Contract No. **T202153104.03**

DOVER BUS CANOPY SOLAR PANELS – READVERTISEMENT

Enclosed is **Addendum No. 2** for the referenced contract consisting of the following:

AD-01											
ADDENDA / REVISIONS				NOT TO SCALE	DOVER BUS CANOPY SOLAR PANELS	CONTRACT		BRIDGE NO.	N/A	ADDENDA AND REVISIONS	SECTION
 ADDENDUM 2 - REVISING INVERTER LAYOUT - 7-30-26						T202153104.03		DESIGNED BY: P. REUTTER			JMT
						COUNTY					SHEET NO.
											KENT

1 ELECTRICAL SITE PLAN - NEW WORK
E-101 SCALE: 1"= 30'-0"

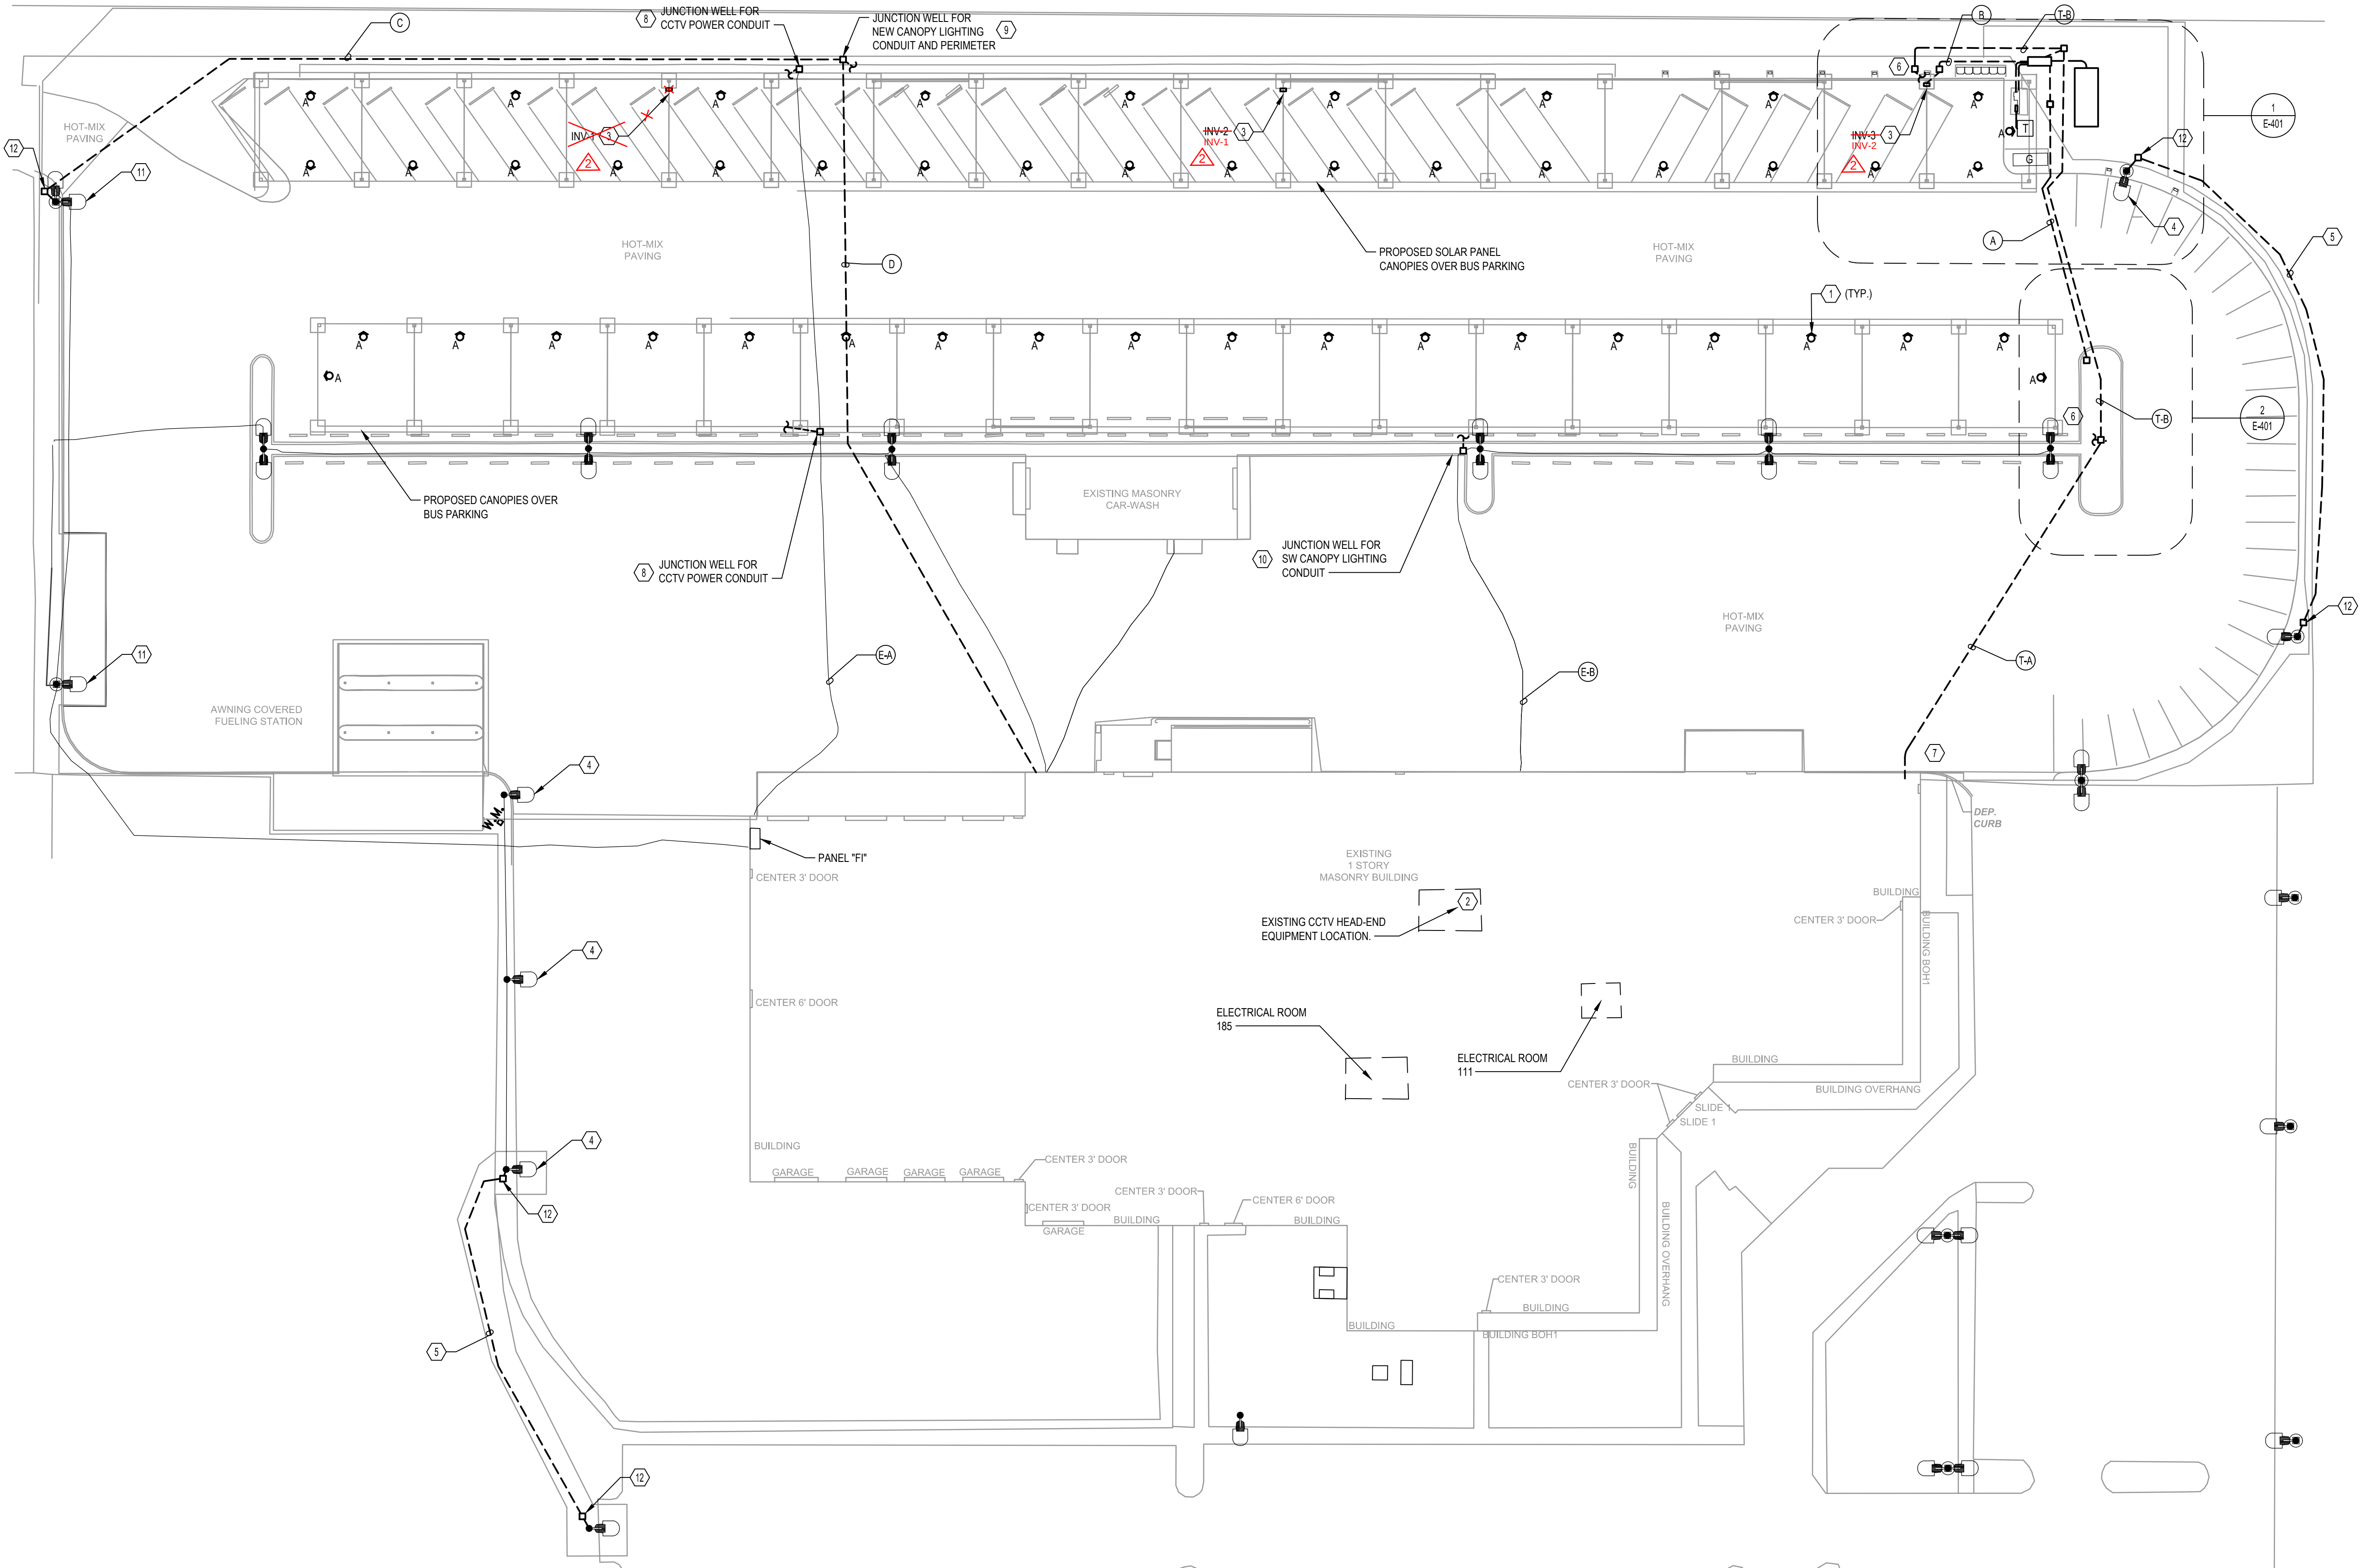
ADDENDUM 2 - REVISING INVERTER LAYOUT - 7-30-26
